C51 Kilburn to West Hampstead

Review of Consultation and Decision Details

Camden Design Team Transport Strategy Service London Borough of Camden 5 Pancras Square Tel 020 7974 5551, Fax 020 7974 6952 DX 2106 Euston, Mhlcom 020 7974 6886	Project C51 - Kilburn to West Hampstead	Drawing Title Consultation Plan Sheet 7 of 7

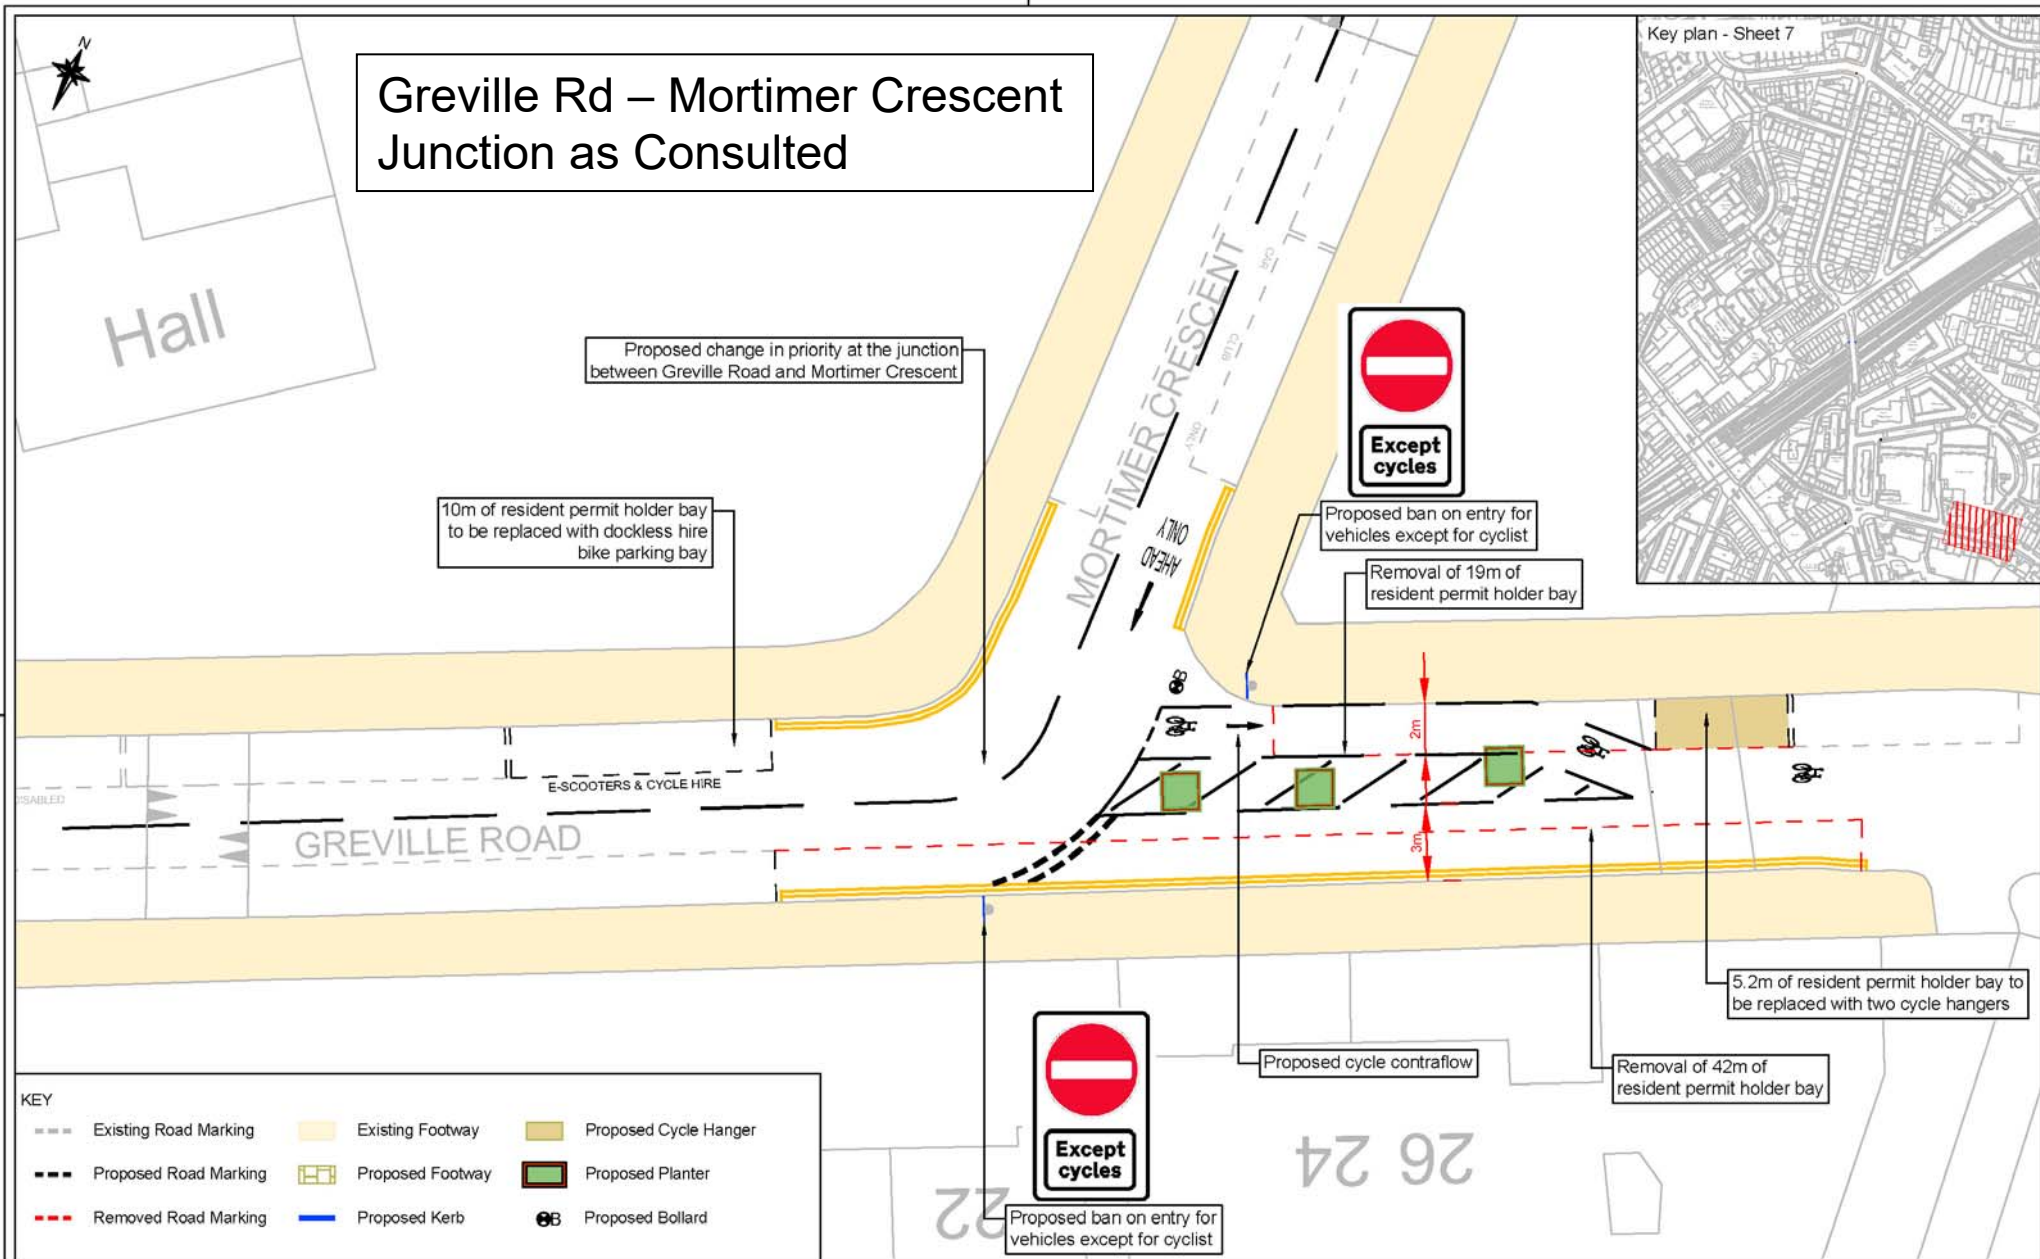
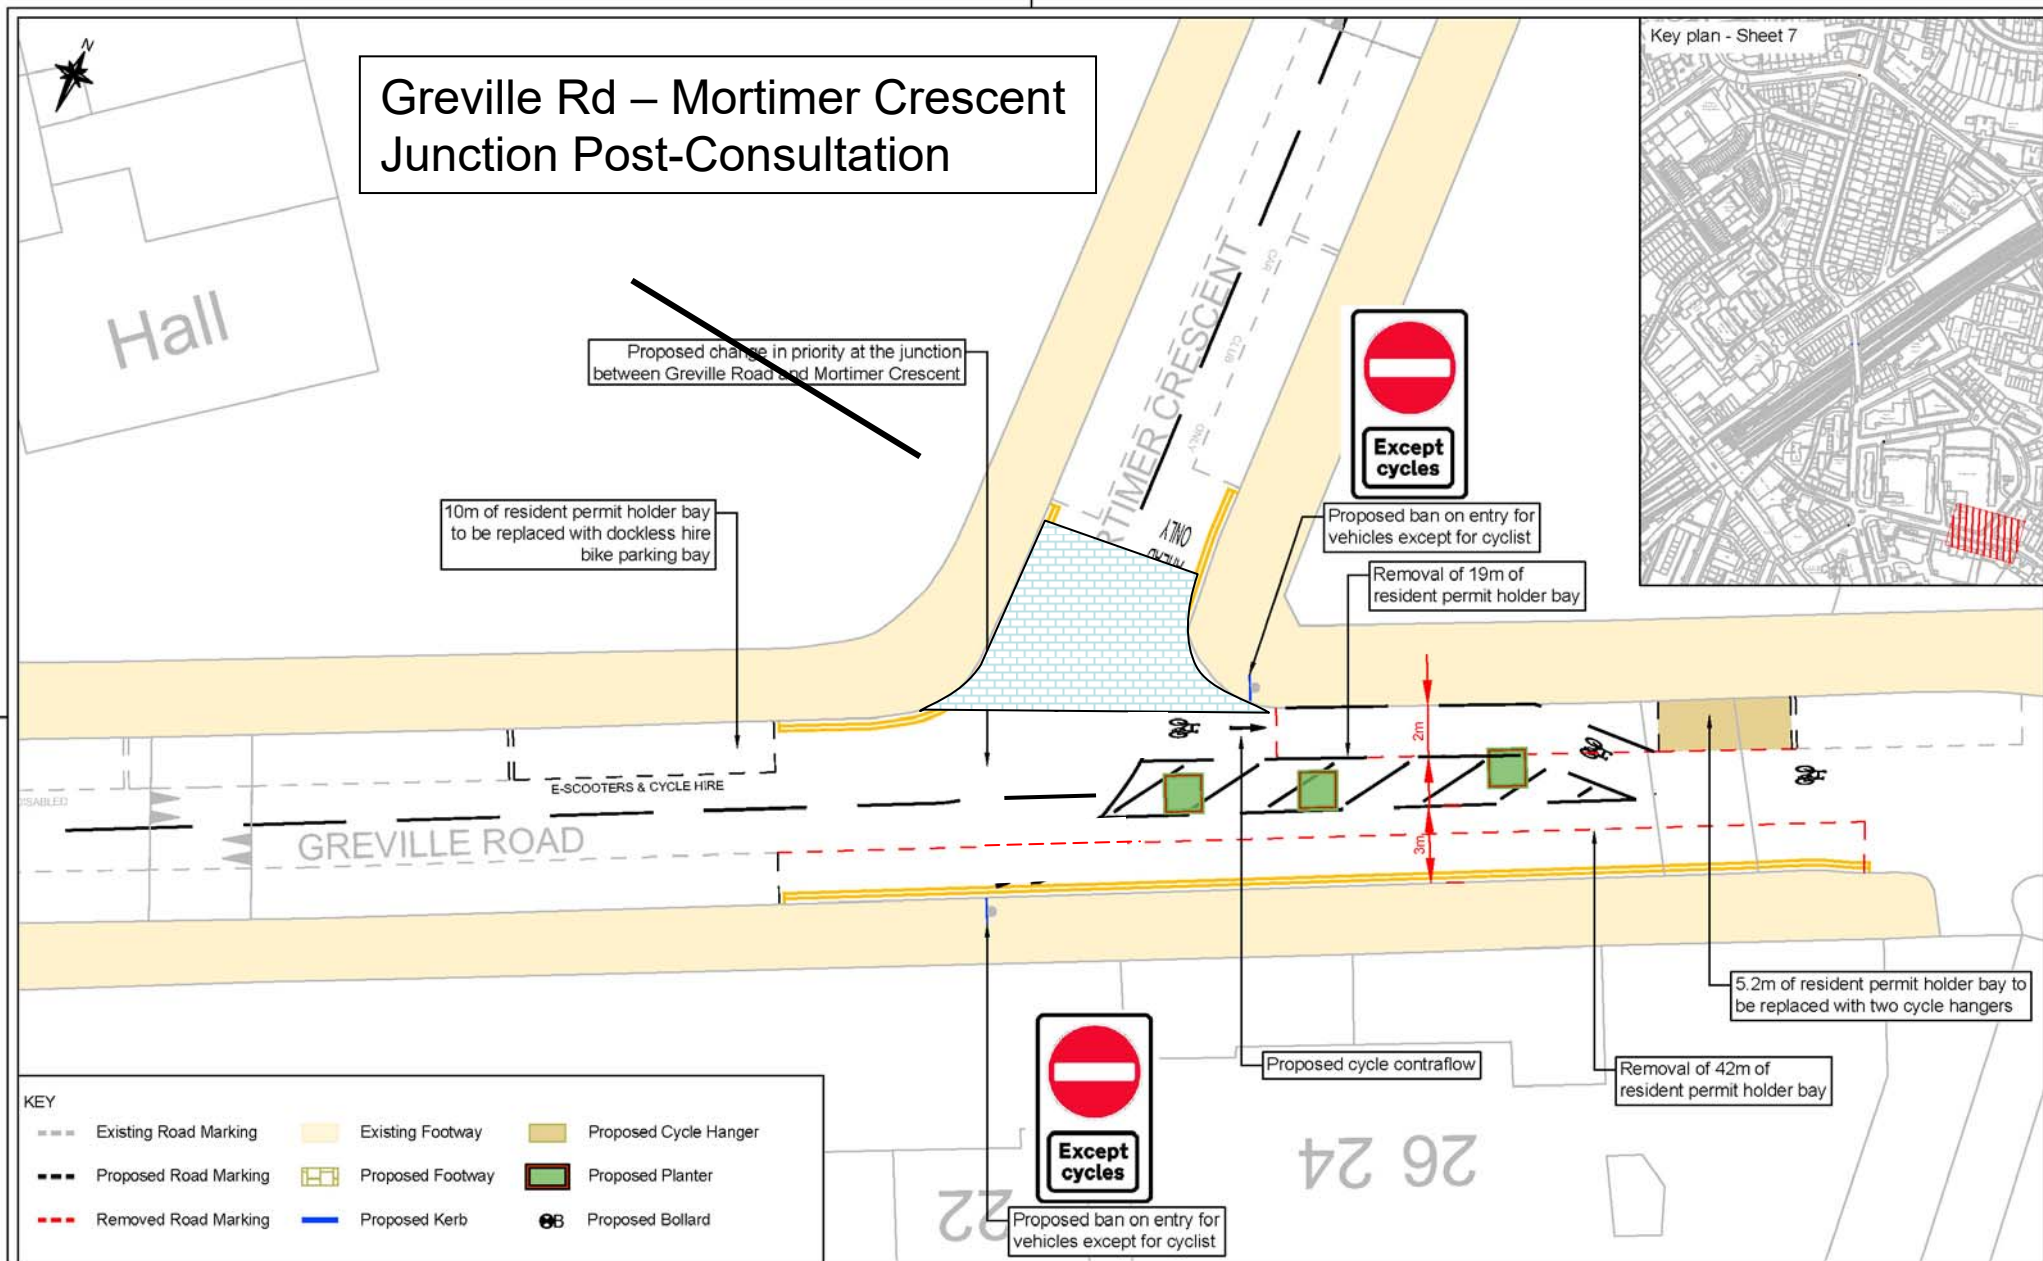
- Kilburn Priory Bridge restriction to be enforced by ANPR rather than bollards (concerns by emergency services)
- Amend design of Mortimer Crescent / Greville Road junction - priority to remain as existing (see attached diagrams)

CCC point raised	Outcome & Justification		Impact	Suggestions/mitigations
1.1	Proposed parallel zebra crossing on Abbey Road/Priory Road is very awkward	Acknowledged but not acted on. Will be raised in Stage 2 and 3 RSAs		NEGATIVE	Review post-installation
1.2	Proposed new layout at the Greville Road / Mortimer Crescent junction is non-intuitive	Redesigned to keep existing priority layout		POSITIVE	
1.3	Make northbound arm of Priory Road one-way northbound for motors	Acknowledged but out of scope. Will consider for future proposals.		NEUTRAL
